**Request For
Administrative Amendment #8**

REQUESTED REVISIONS TO SITE PLAN:
ADDITION OF 12,793 SF WAREHOUSE/OFFICE BUILDING ON PREVIOUSLY APPROVED PAD SITE.

ADMINISTRATIVE AMENDMENT
 FILE: 06AA-1025 Project # 1000554
 ±12,793 S.F. OFFICE/WAREHOUSE BUILDING.
 APPROVED BY: *Russell Rents* DATE: 21 Mar 08

**Master Development Plan
South Eubank State Land Office
Eubank, SE Albuquerque, NM
Site Data**

SITE PLAN

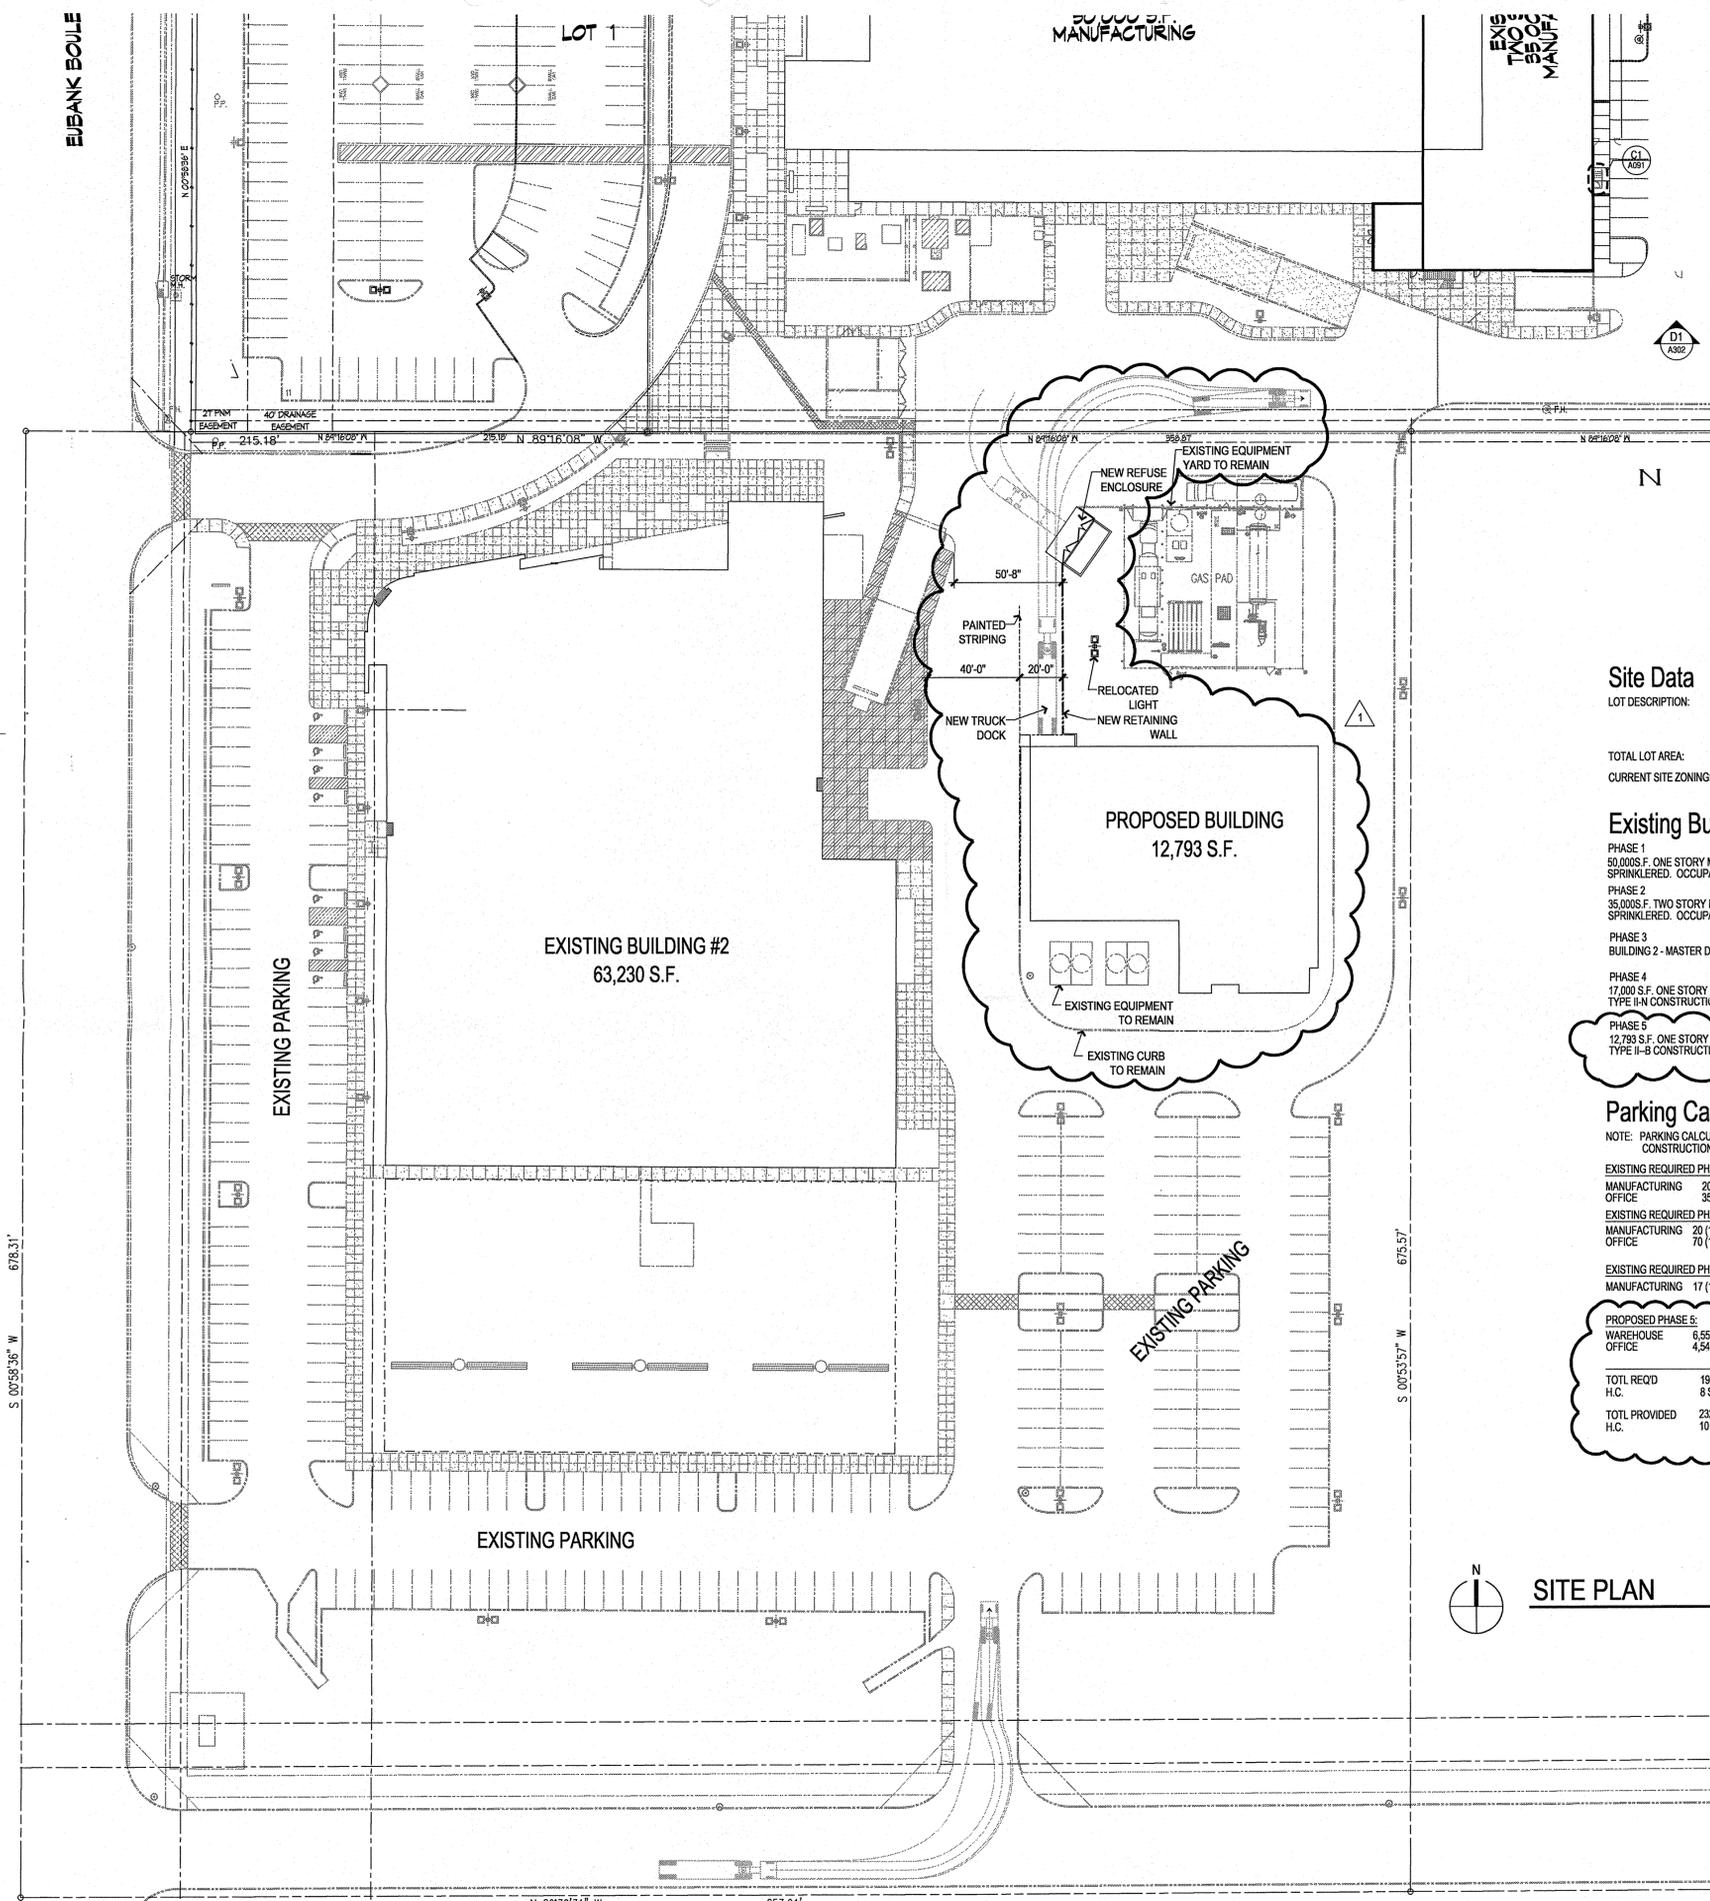
PROPOSED BUILDING
12,793 S.F.

NEW REFUSE ENCLOSURE

NEW TRUCK DOCK

RELOCATED LIGHT

NEW RETAINING WALL
